# Construction Documentation Report Lockport City Landfill

## Remedial Action Construction

**The City of Lockport**  
Lockport, New York

**URS Consultants, Inc.**  
282 Delaware Avenue  
Buffalo, New York 14202

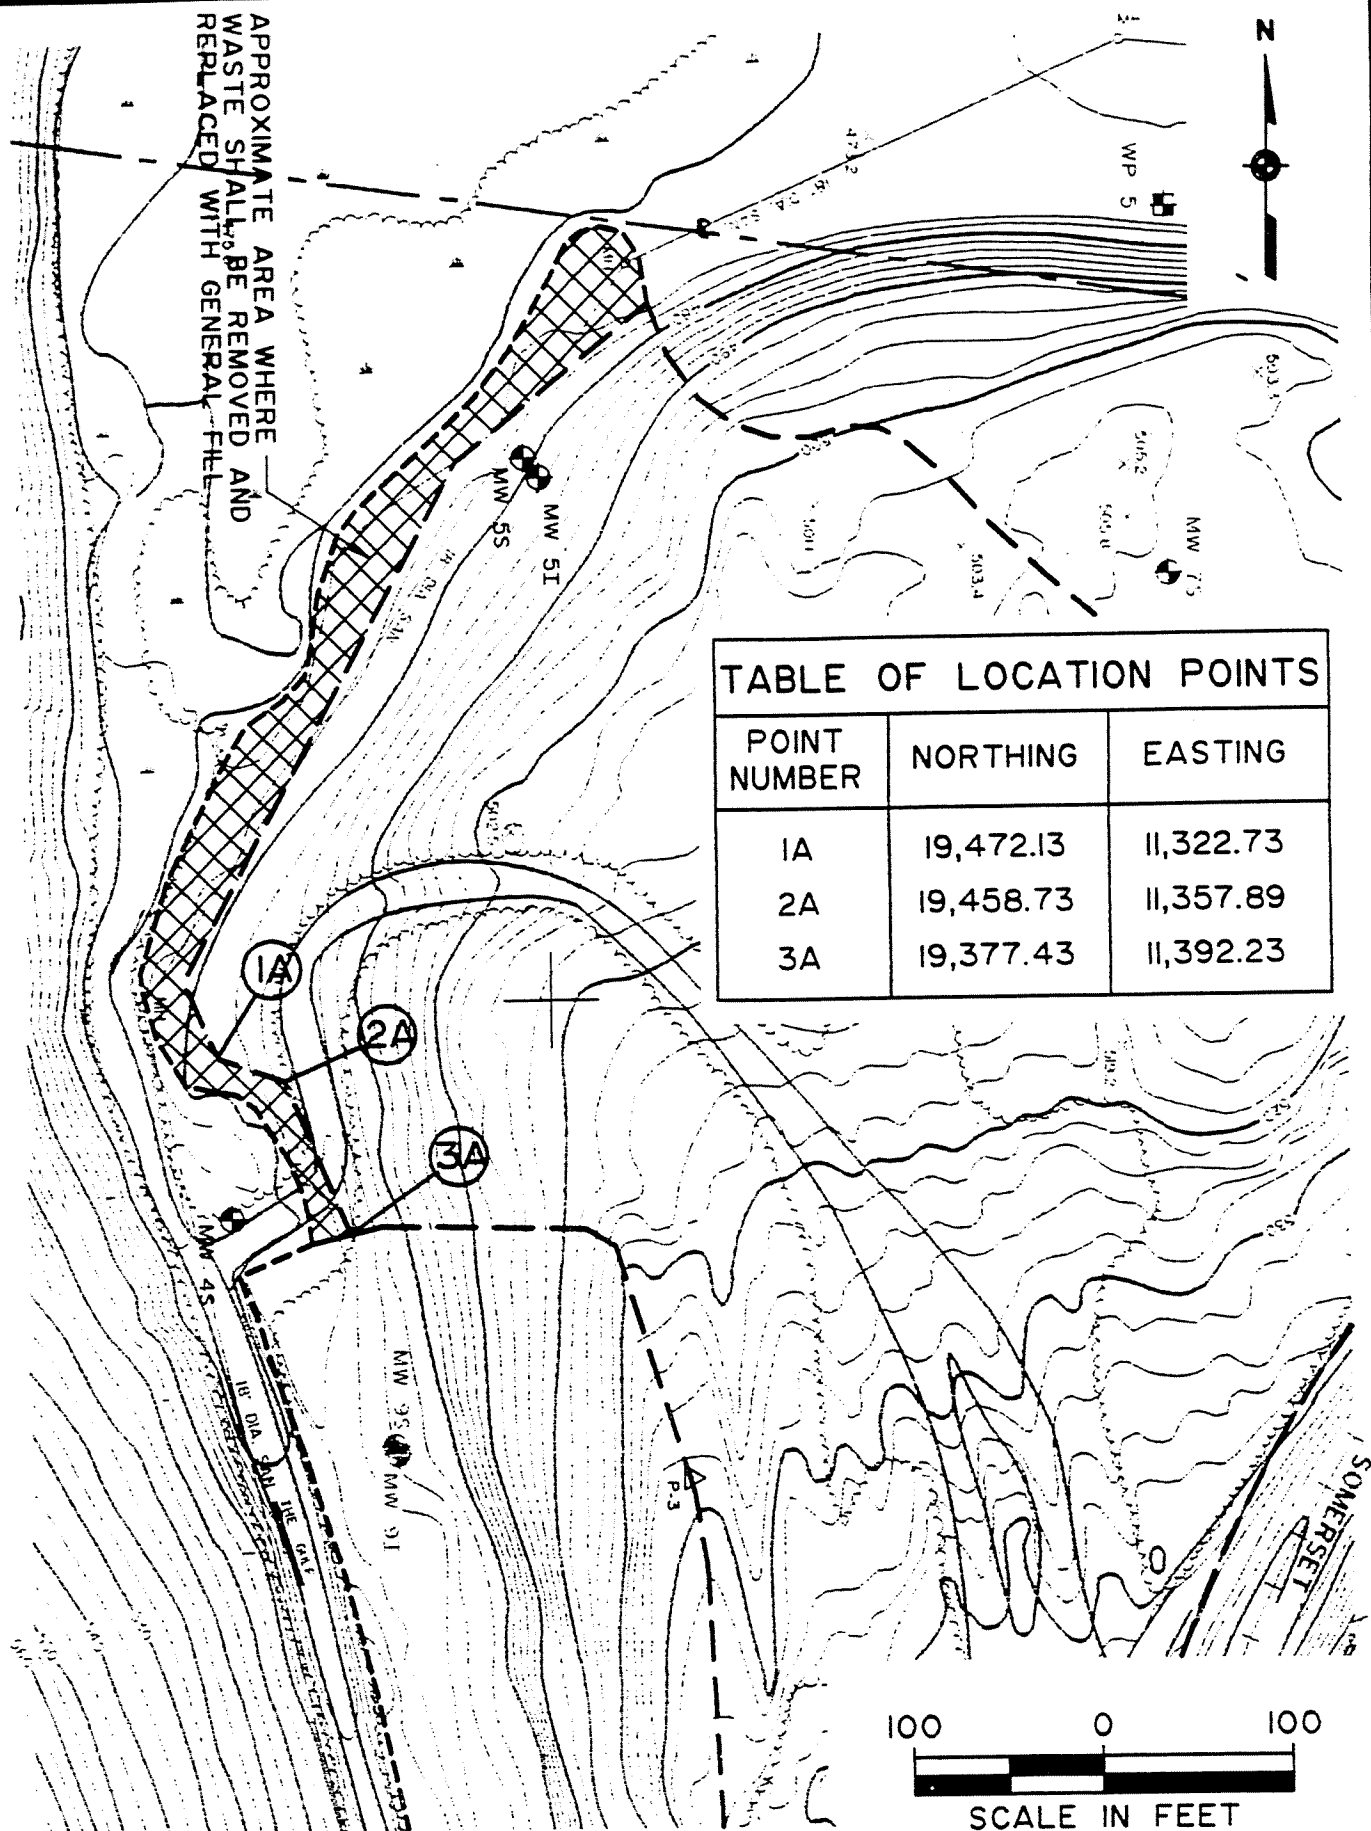
Clarify the limits of the following as shown on attached Figure No. 1:

FIGURE 1

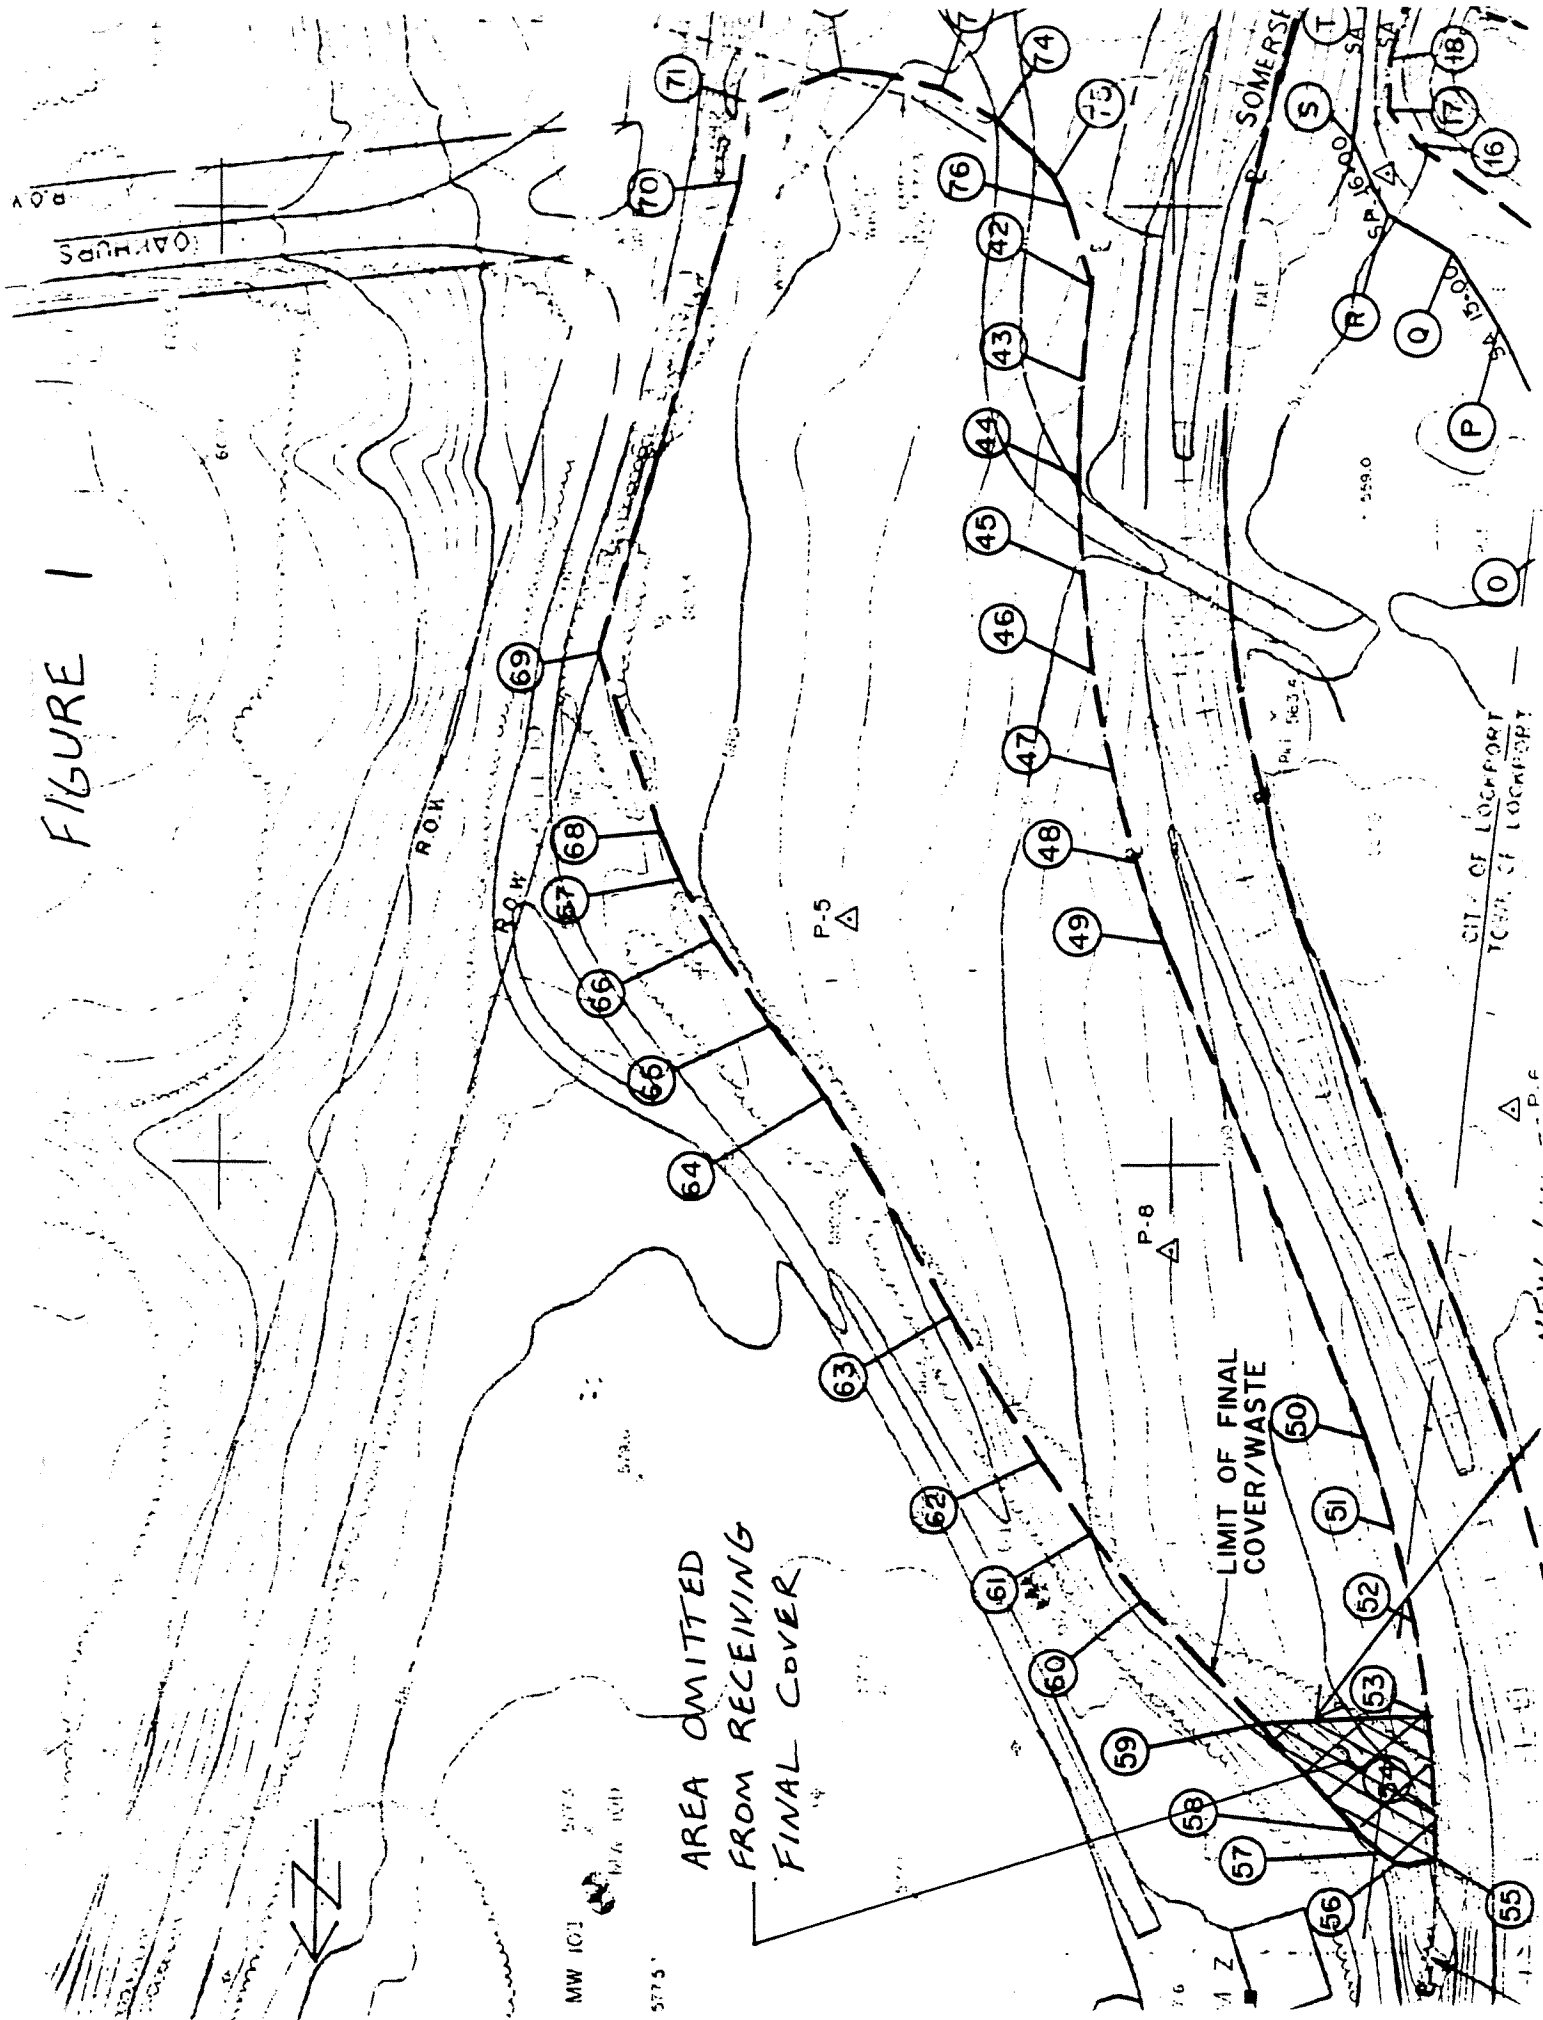
Clarify the limit of final cover as shown on attached Figure No. 1.

DETAIL 1 (DC 17+00 - DC 16+50)

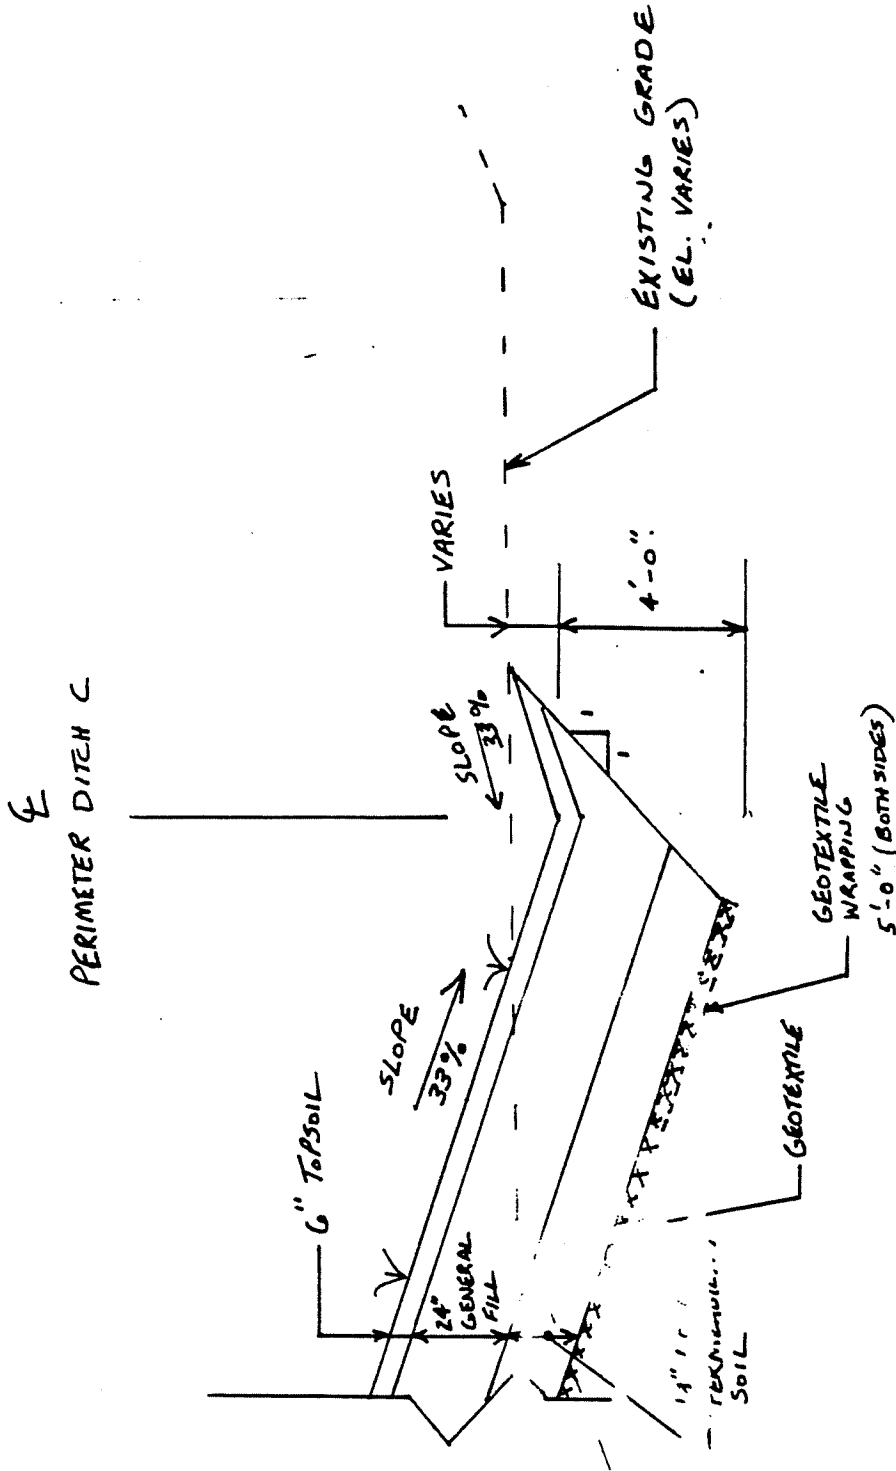
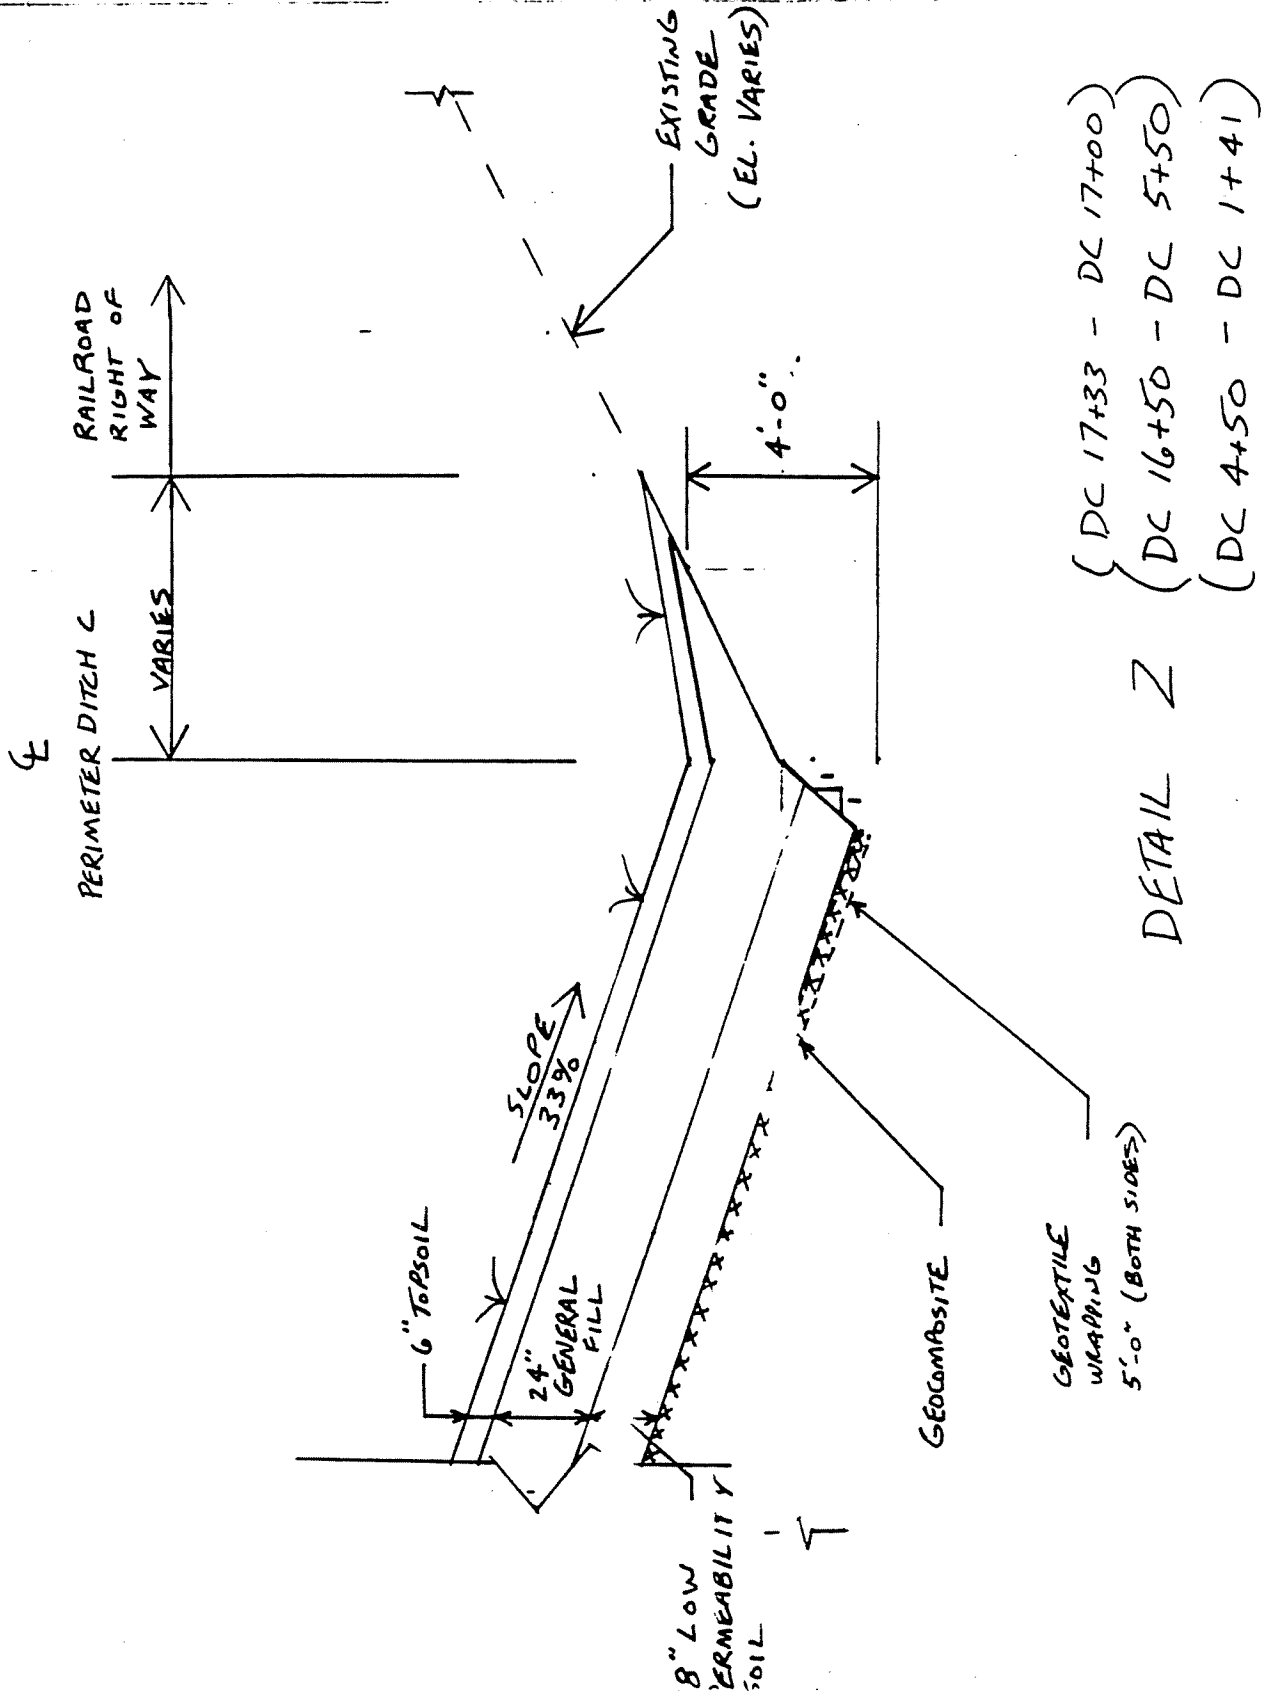
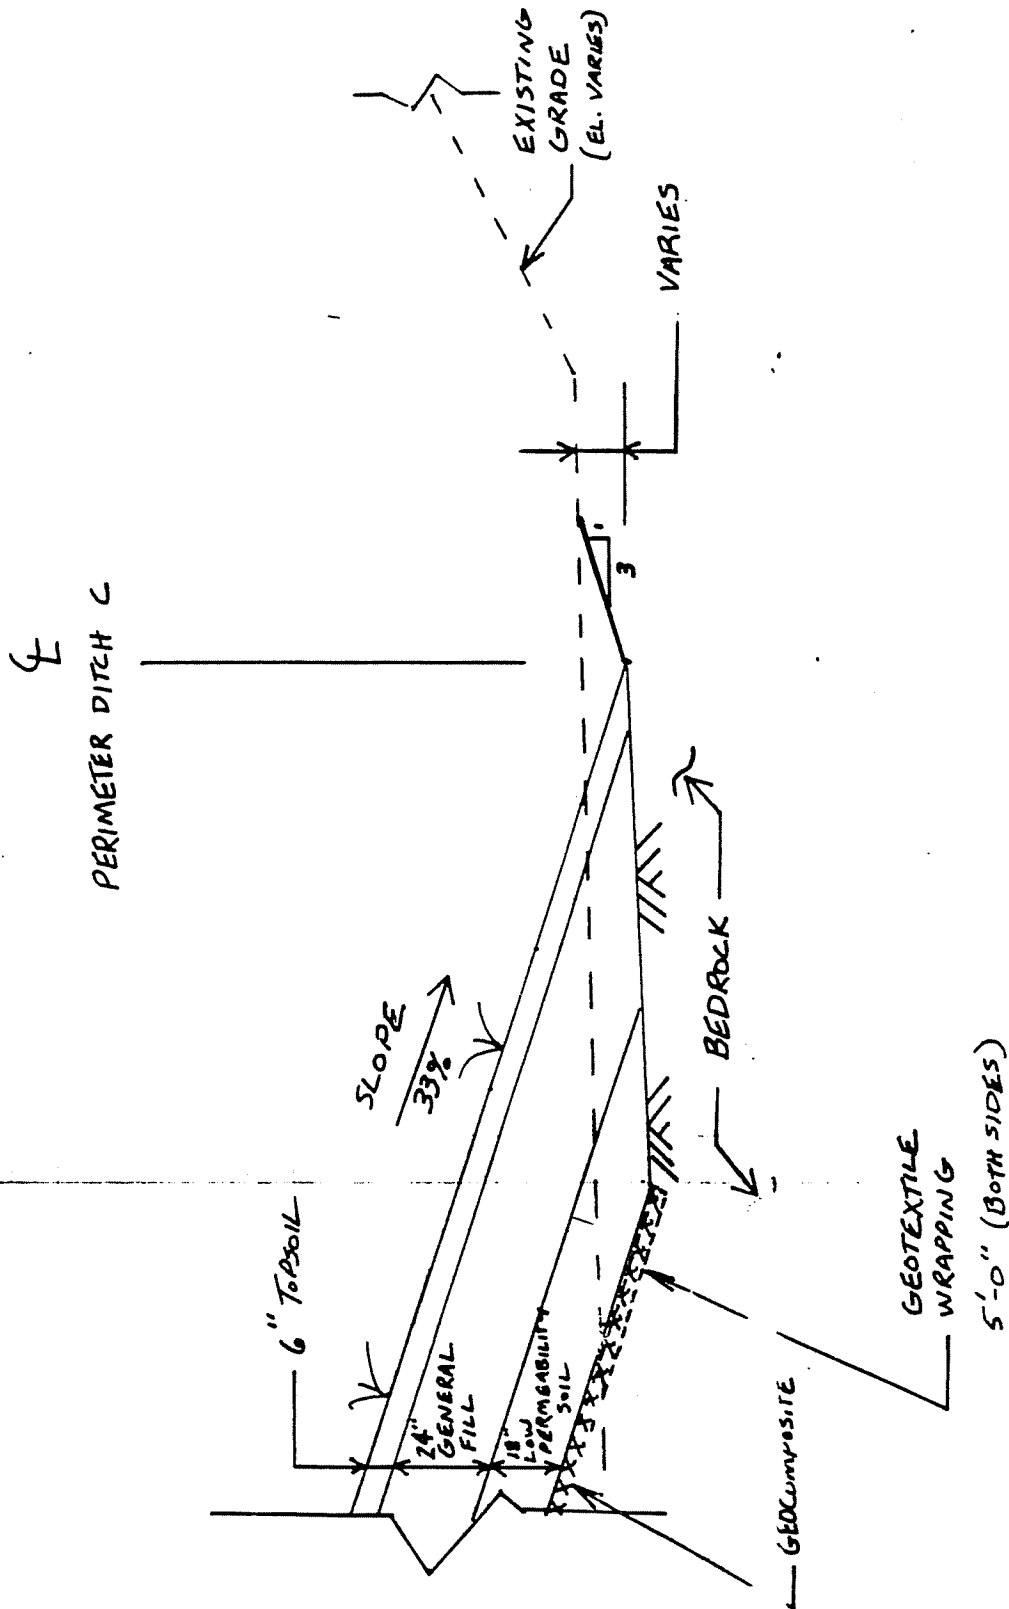
Clarify Perimeter Ditch C from DC 1+41 to DC 17+33 as shown on Attached Details 1, 2, and 3. The stationing where each respective detail applies is based on survey information submitted by Suburban Pipe Line Co. and is approximate only. The actual limits where each detail applies shall be field determined.

Clarification needed to reflect actual field conditions (i.e. Ditch modified to prevent excavation of the railroad embankment ) and per Suburban Pipe Line Co. request
